# DRAINAGE INFORMATION SHEET

PROJECT TITLE: TANGLEWOOD SUBDIVISION ZONE ATLAS/DRNG. FILE #: J-101D26  
 DRB #: 96-S44 EPC #: \_\_\_\_\_ WORK ORDER #: 5760.81  
 LEGAL DESCRIPTION: TRACTS 231 & 232, AIRPORT UNIT, TOWN OF ATRISCO GRANT  
 CITY ADDRESS: N/A

RE: ENGINEER CERTIFICATION FOR TANGLEWOOD SUBDIVISION (J10-D26)  
FINANCIAL GUARANTEE RELEASE CERTIFICATION STATEMENT DATED 3/4/98

RE: DRAINAGE PLAN FOR TANGLEWOOD SUBDIVISION (J10-D26) ENGINEER'S  
STAMP DATED 4/29/97

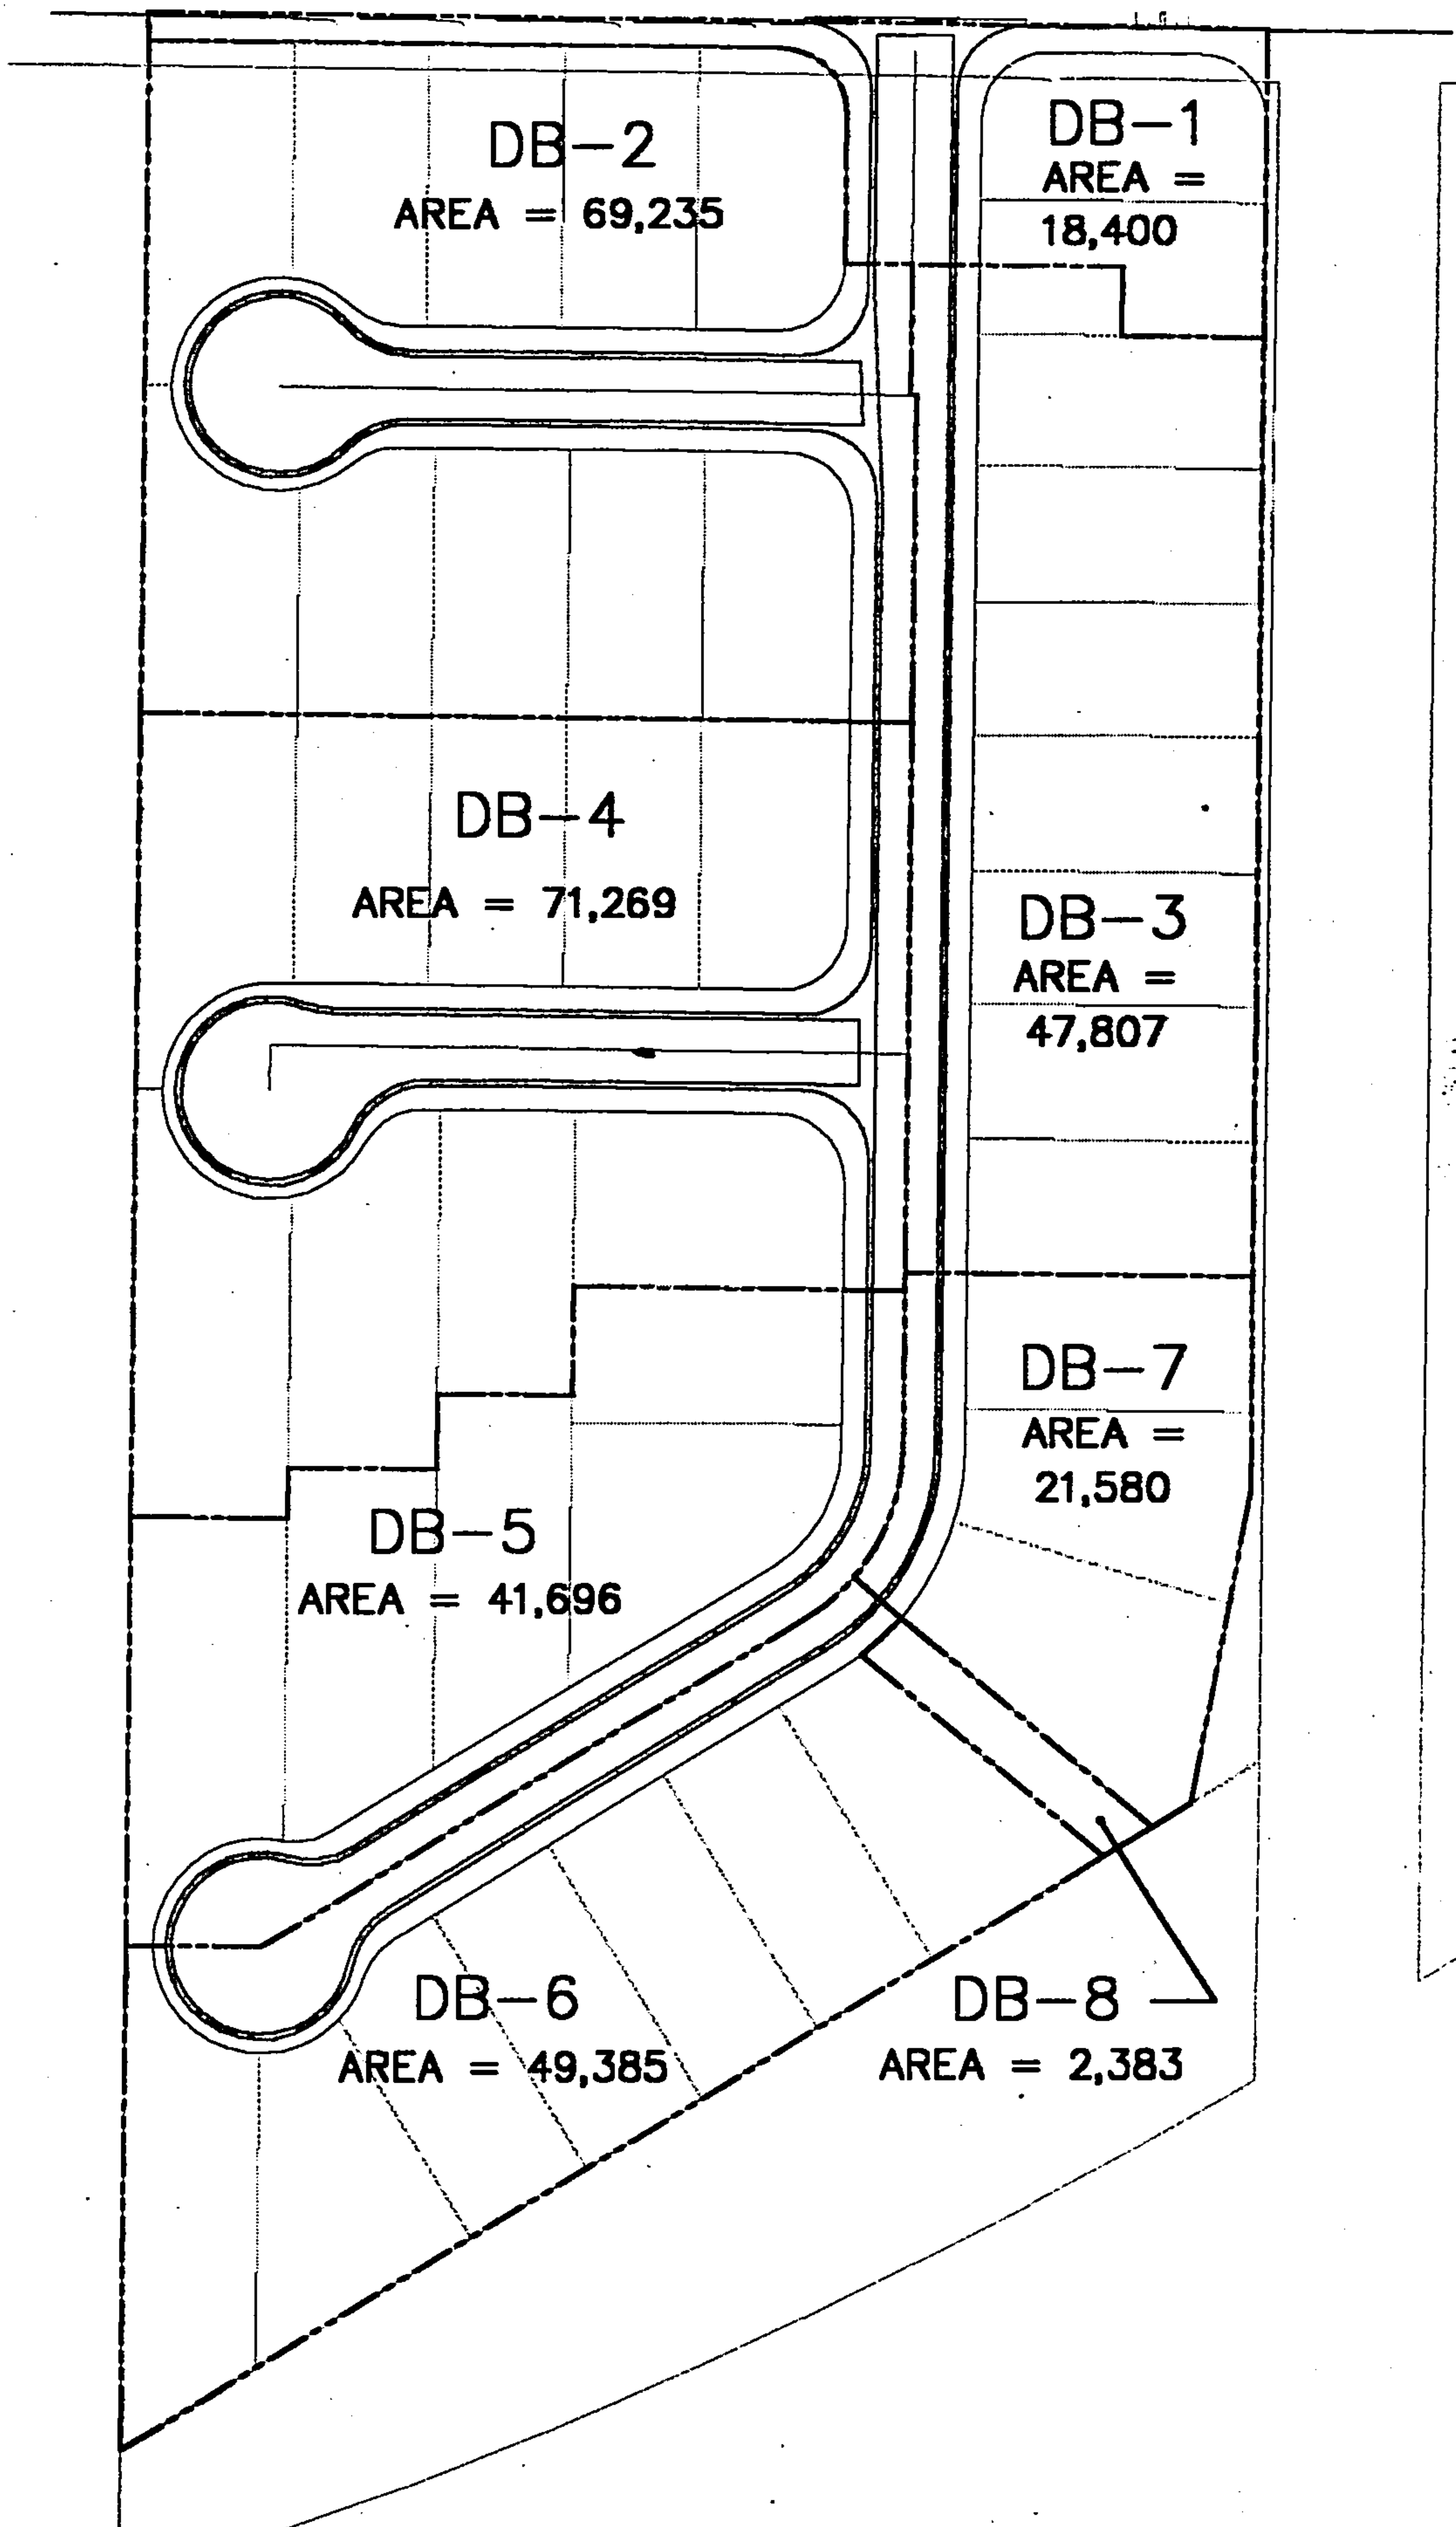
1. Pad elevations will need to be shown to full-mean-level designation.
2. More separation will be required on your proposed "A" inlets on the west side of Tangle-Wood.
3. Copy of the infrastructure list with your resubmittal.

Please find enclosed Revision No. 1 to the above referenced Grading and Drainage Plan. The revision is to address comments in your letter of May 9, 1997 which required that pad elevations be shown to full-mean level designation and that more separation be provided between curb inlets on the west side of Tanglewood. Also, there is a revision to show a 6:1 exterior slope around the proposed retention pond, as requested by AMAFCA. In all other respects, the Grading and Drainage Plan is as previously submitted. Also, as you requested please find enclosed a copy of the approved Infrastructure List.
